**AGENDA OF THE PLANNING BOARD**

June 4, 2020

**Gasland - 1663 Route 9**

**1663 Route 9 (Grid #6158-14-498418) – GasLand Holdings Corp. (Zeidan Nesheiwat) (Owner and Applicant); Chazen Companies (Consultant) – Site Plan.**

designed	checked
SPL	CPL
date	scale
03/12/20	1"=10'
project no.	
82010.00	
sheet no.	
<b>C130</b>

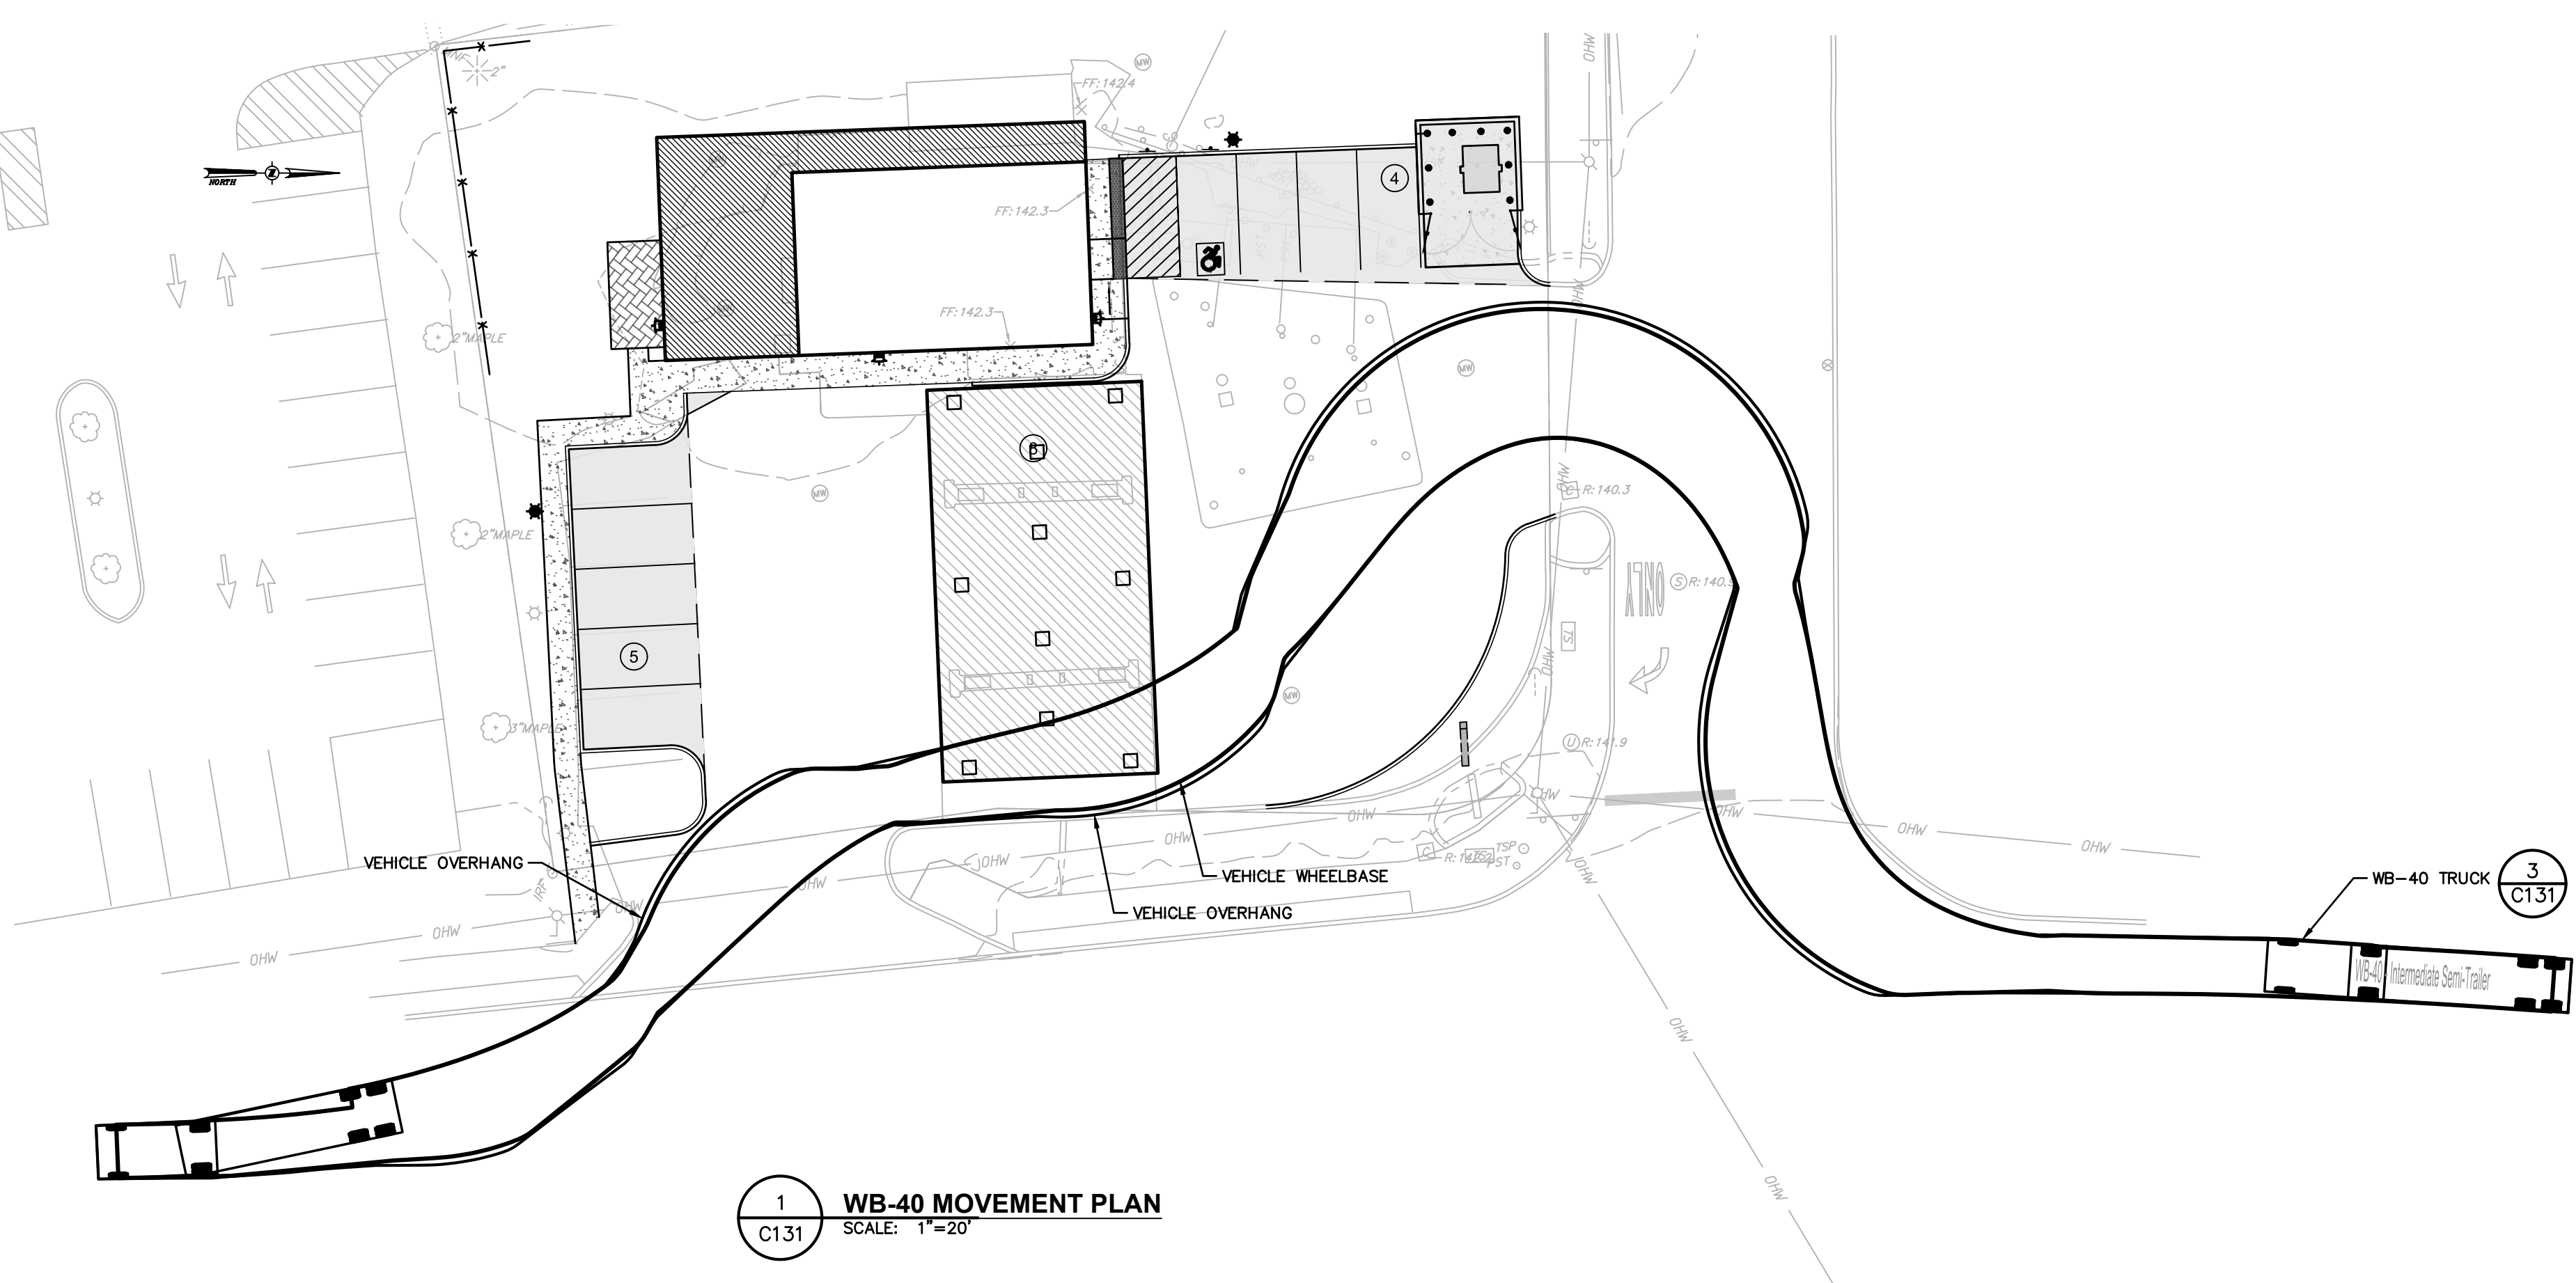
*Sheet C130*

**Response: The existing sidewalk and handicap parking area have been revised as shown on Sheets C130 and C140.**

**Response:** A sidewalk has been added to connect the convenience store to the sidewalk along Route 9; see sheet C130.

designed	checked
TCC	CPL
date	scale
03/12/20	1"=10'
project no.	
82010.00	
sheet no.	
<b>C180</b>

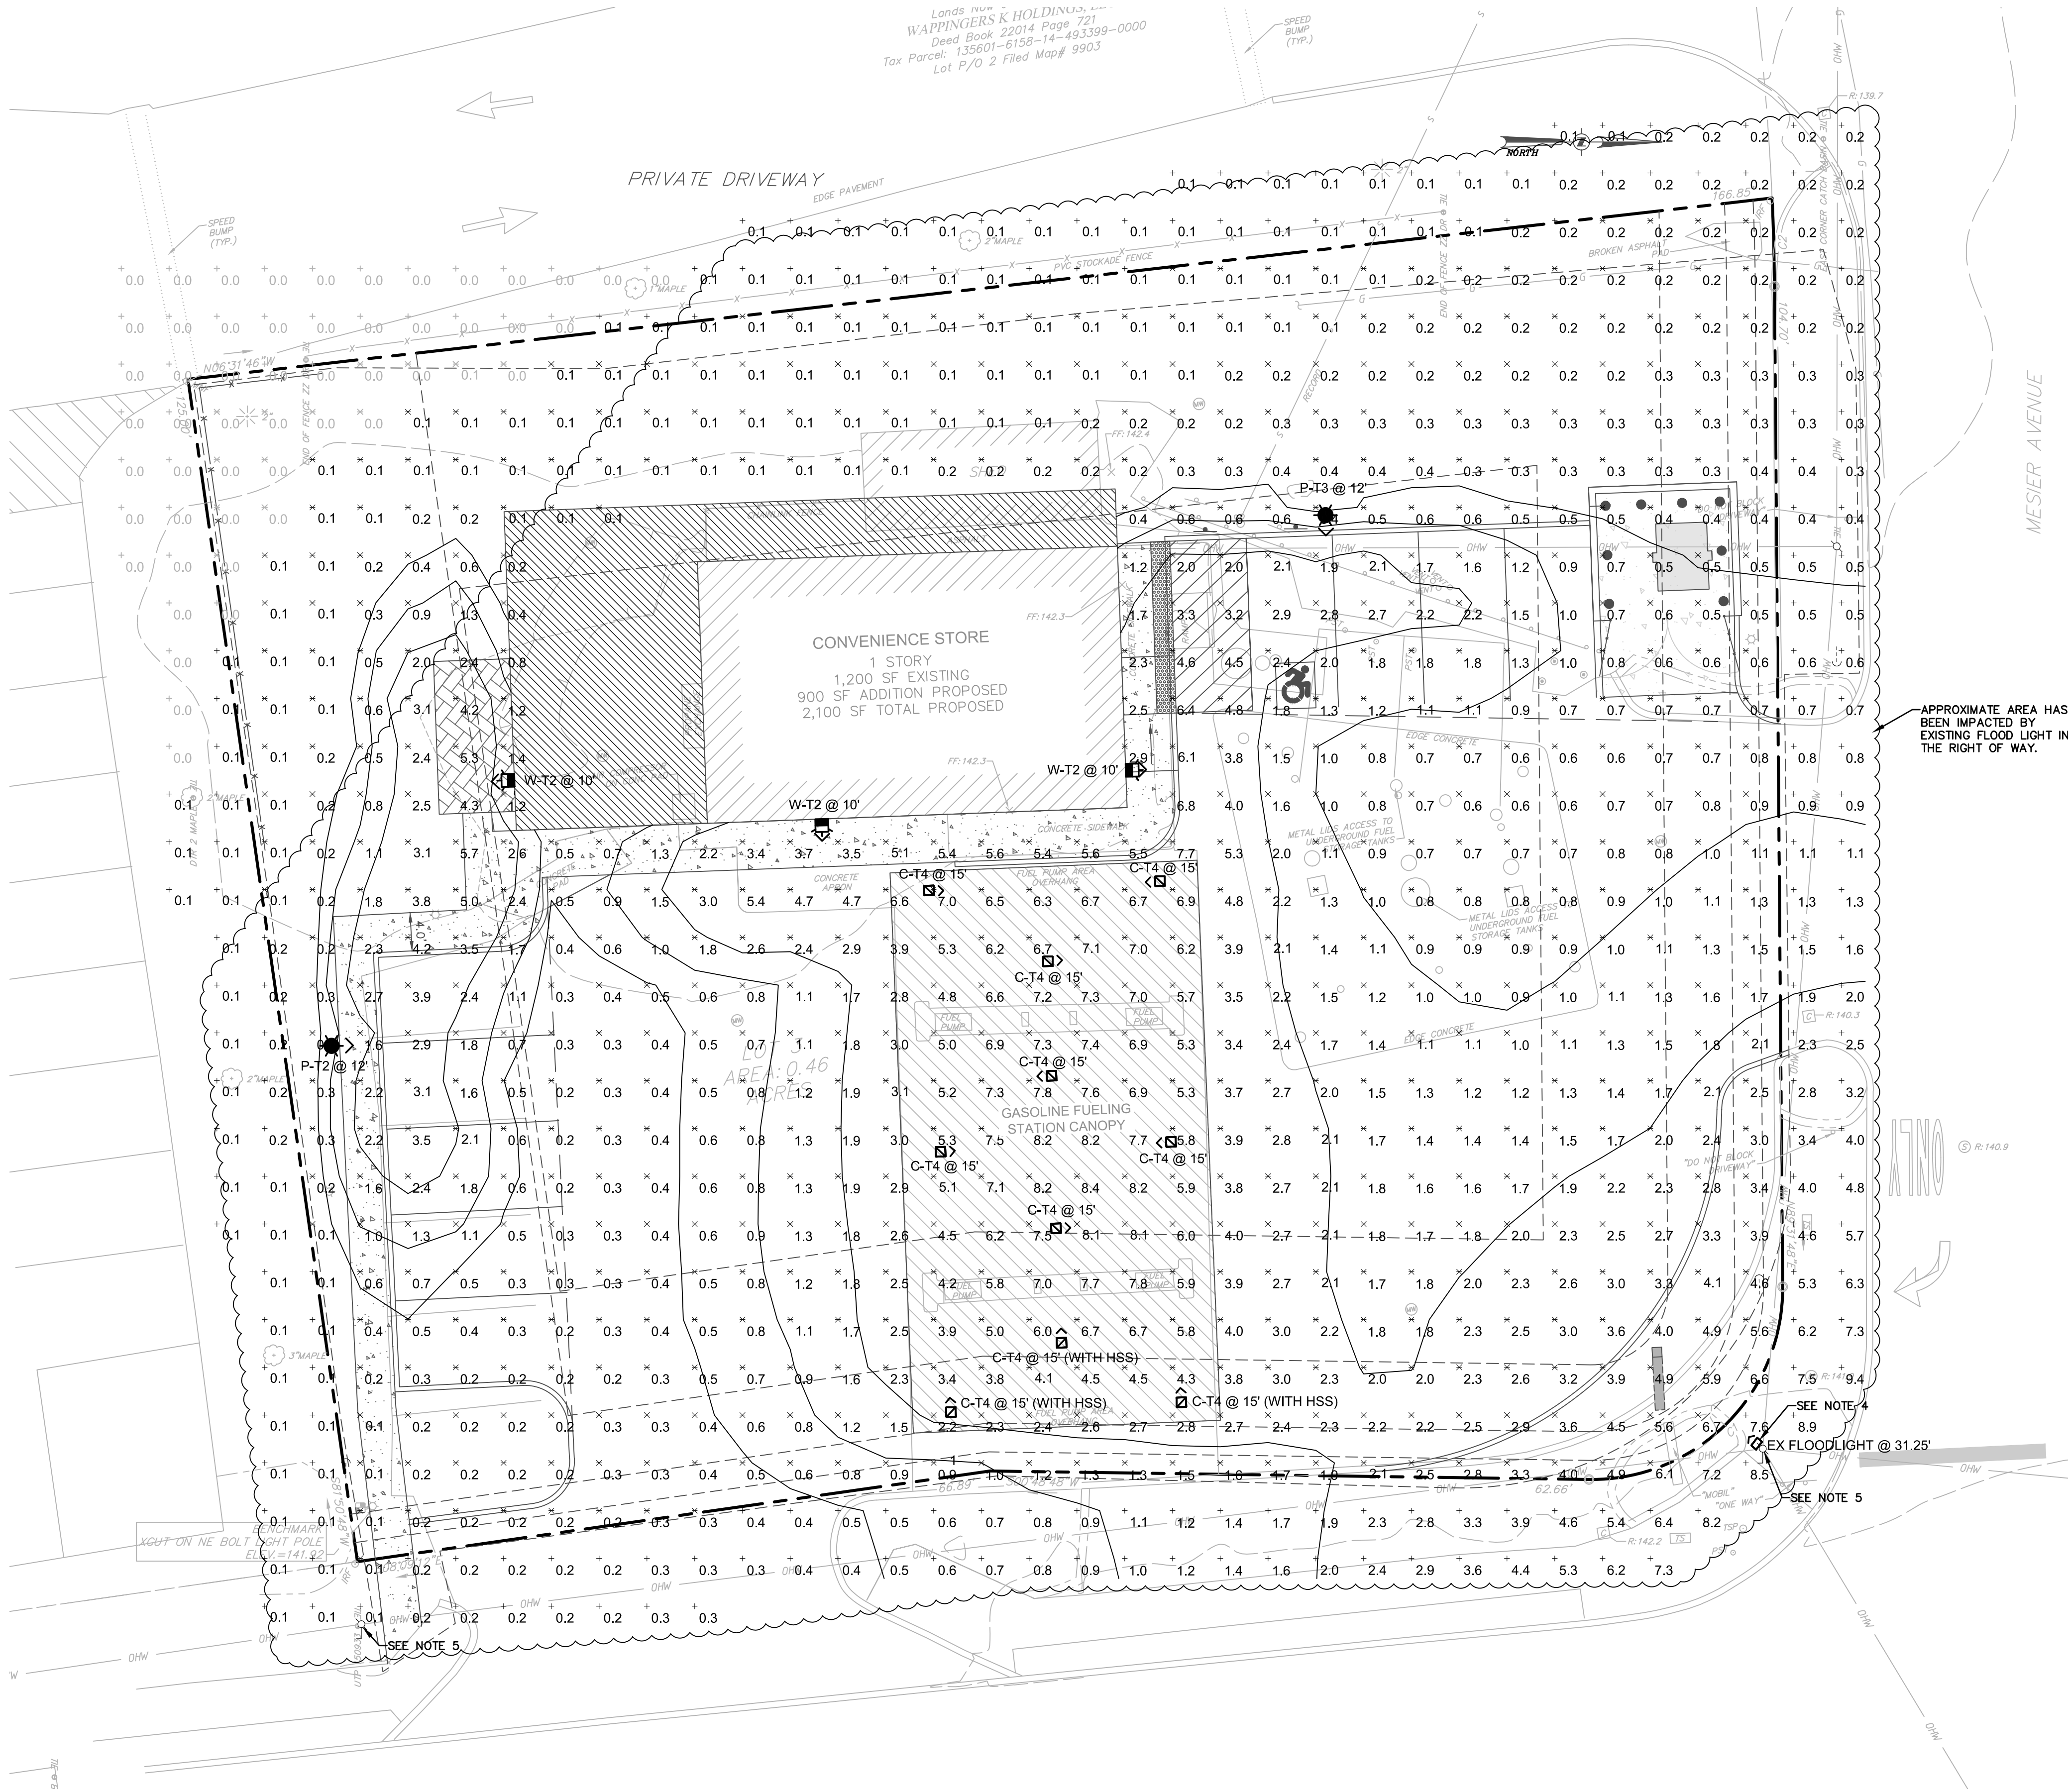
*Sheet C180*

**Response: Additional landscaping has been provided; see sheet C180.**
